Model: Taurus-C1a/C1b	Date: 20-Jun-11	No.: RD074001d
-----------------------	-----------------	----------------

Subject: Firmware Release Note: OpePanel.EXP		Prepared by: S. Sasaki	
From: 1st PP Tech Service Sect., PP Tech Service Dept.			
Classification:	<input type="checkbox"/> Troubleshooting	<input type="checkbox"/> Part information	<input type="checkbox"/> Action required
	<input type="checkbox"/> Mechanical	<input type="checkbox"/> Electrical	<input type="checkbox"/> Service manual revision
	<input type="checkbox"/> Paper path	<input type="checkbox"/> Transmit/receive	<input type="checkbox"/> Retrofit information
	<input type="checkbox"/> Product Safety	<input checked="" type="checkbox"/> Other (Firmware)	<input checked="" type="checkbox"/> Tier 2

Subject: Field Service Manual Correction		Prepared by: K. Tsutsui	
From: PP Service Planning Department 1G			
Classification:	<input type="checkbox"/> Troubleshooting	<input type="checkbox"/> Part information	<input type="checkbox"/> Action required
	<input type="checkbox"/> Mechanical	<input type="checkbox"/> Electrical	<input checked="" type="checkbox"/> Service manual revision
	<input type="checkbox"/> Paper path	<input type="c

<Multi Folding Unit (D521) \ Accessories >

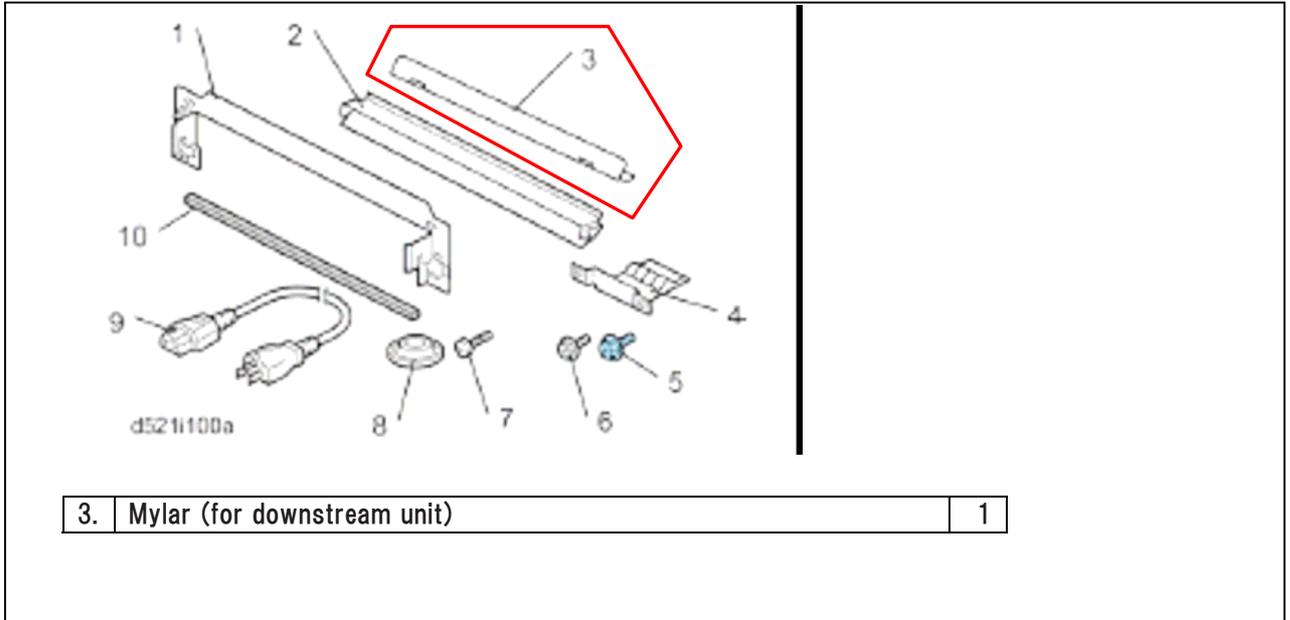
Mylar was added to the accessories.

< Fusing Unit \ Heating Roller >

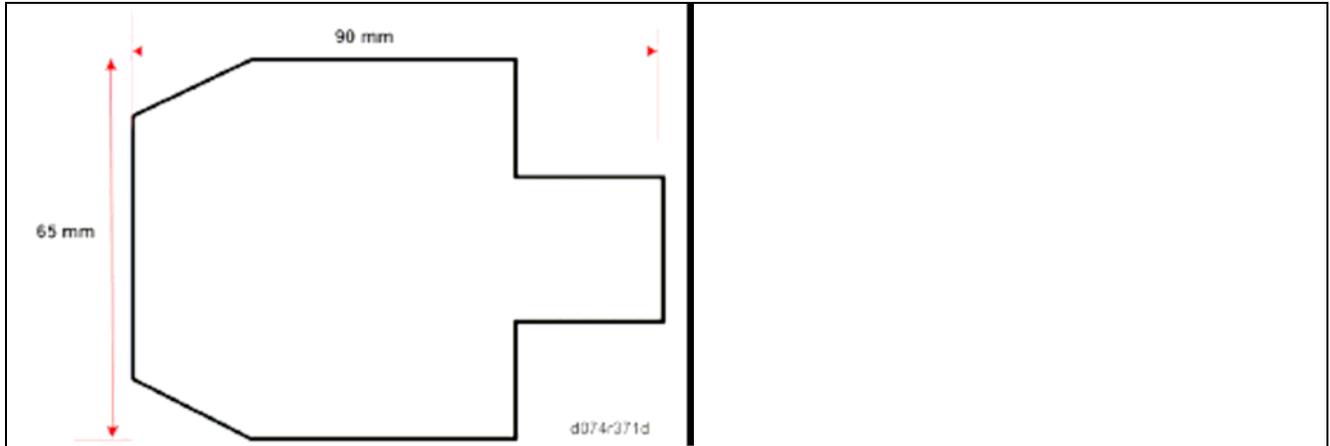
The following procedure was deleted as grease application for the Hot Roller Bearings is no longer needed.

< Left Drawer \ Duplex Transport Sensor 1 >

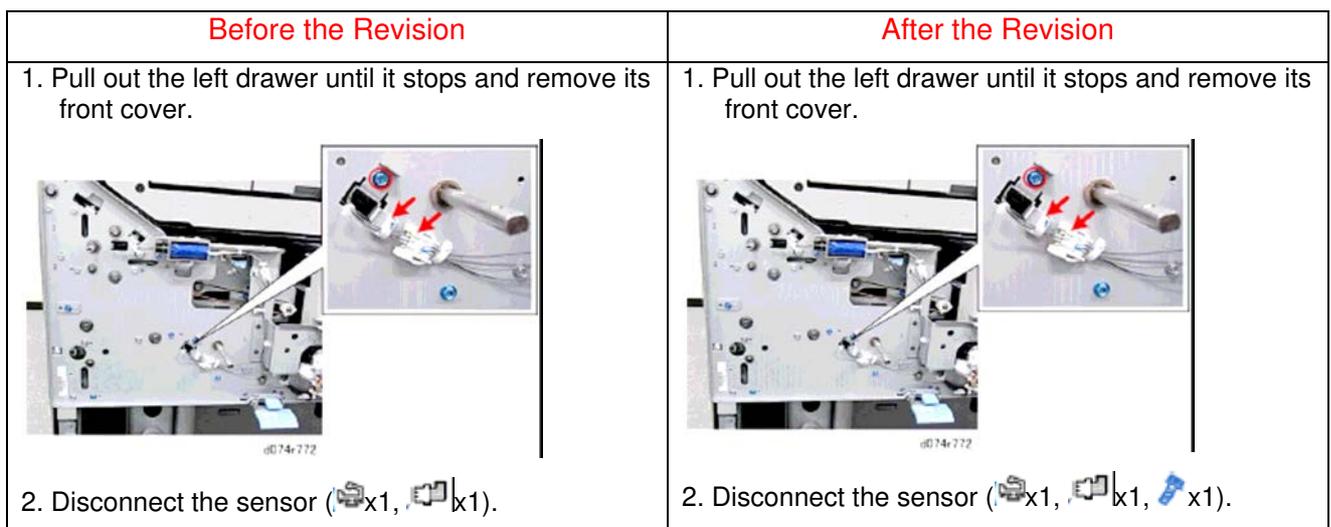
Missing description was added.
